Change of marking - Ethernet PCB Terminal (LSF-SMT)

1. General Overview

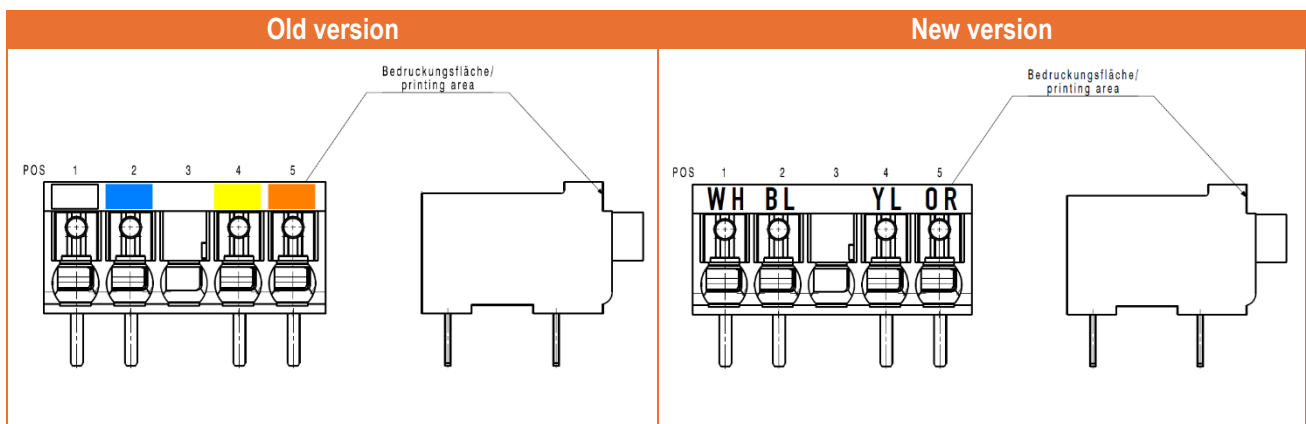
The marking on the Ethernet terminals (LSF-SMT) will be changed from multicolored to white. This adjustment enables a more stable and economical production process, which contributes to ensuring consistent product quality and delivery capability in the long term. The technical function and labeling remain unchanged, so that the change has no effect on the application.
